Explosives Safety Submission Time-Critical Removal Action Parcel XVI Paint Waste Area Munitions Response

Former Mare Island Naval Shipyard,
Vallejo, California

First Amendment

April 2009

**FIGURE 1-2
SITE LOCATION MAP**

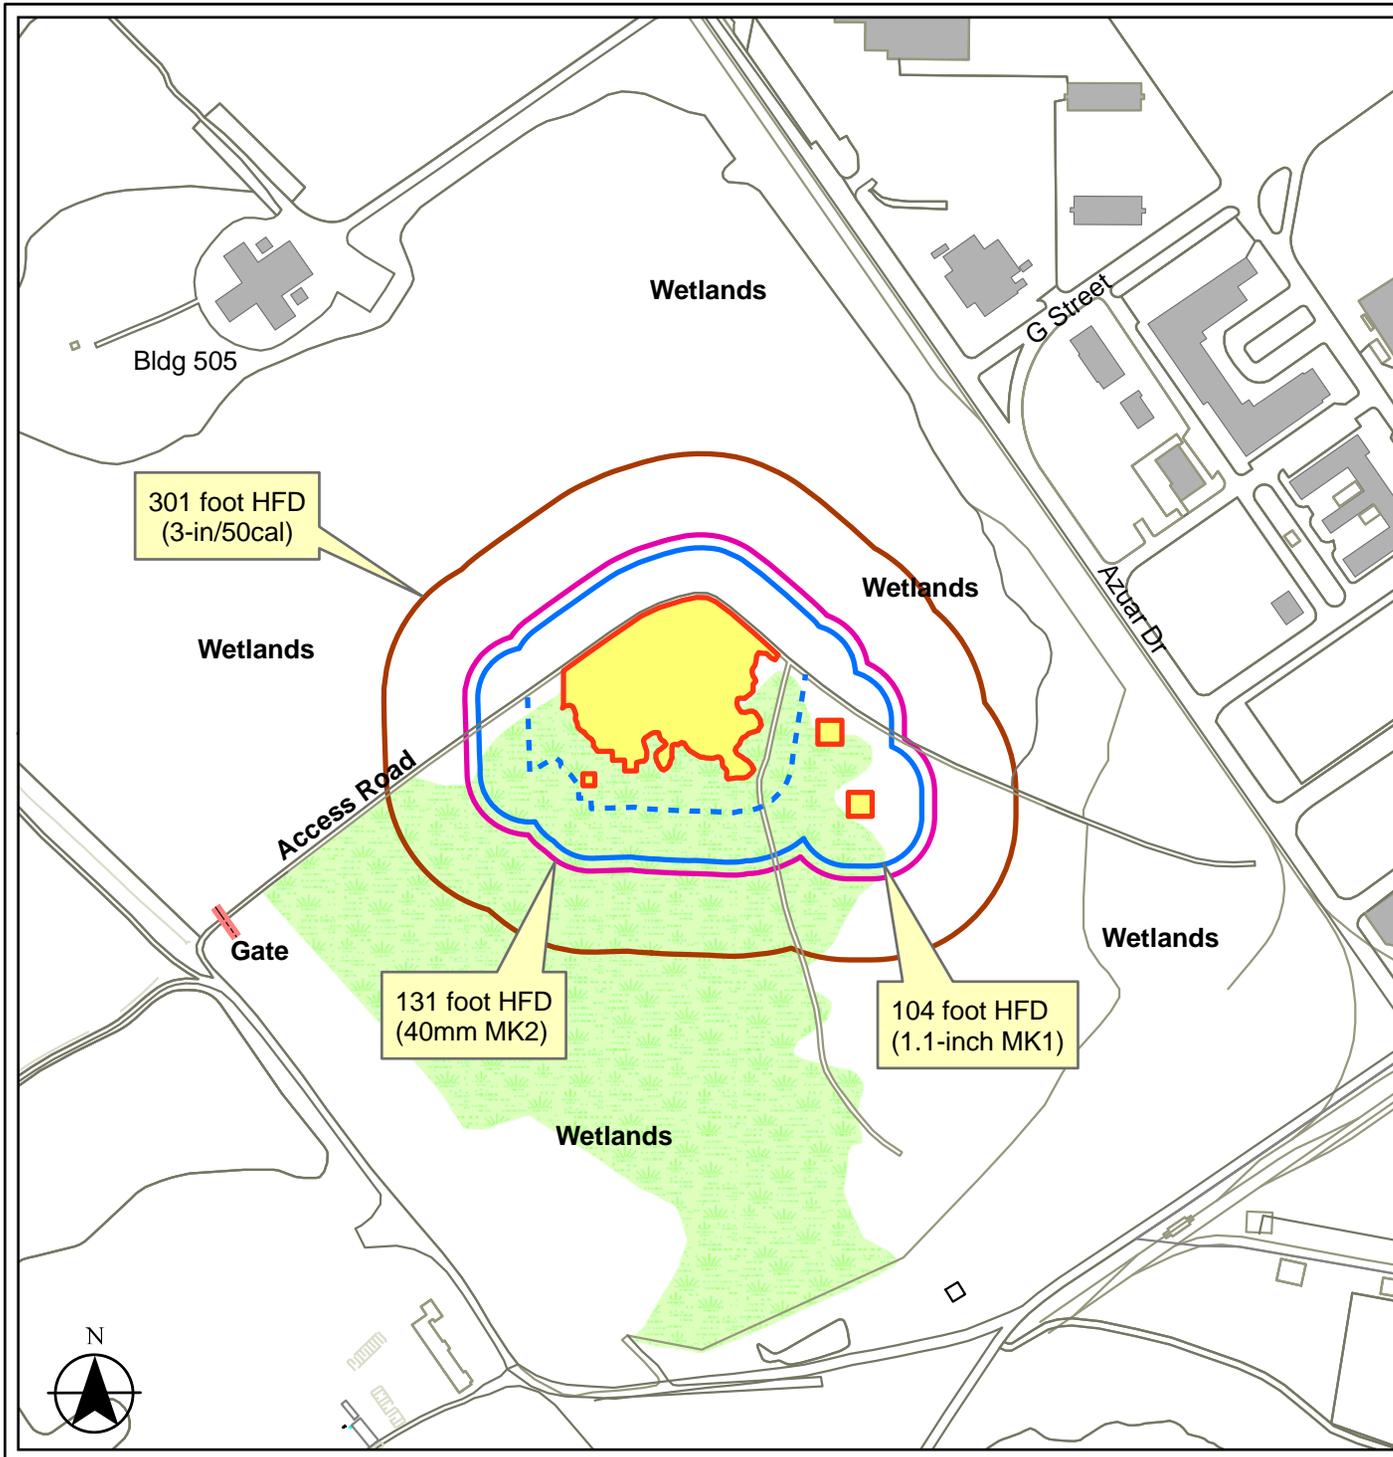
9. *Figure 1-2, changed to reflect 1.1-inch (104'), 40mm (131'), and 3-in/50 cal (301') exclusion zone arcs.*
10. *Figure A-3, revised to indicate a 301' exclusion zone (reflecting the largest MGF, the 3-in/50 cal projectile) for both the soil excavation and soil screening areas.*
11. *Deleted Figure 8-2 (Excavation Shield Box).*
12. *Deleted Figure 10-1 (Traffic Control Plan).*
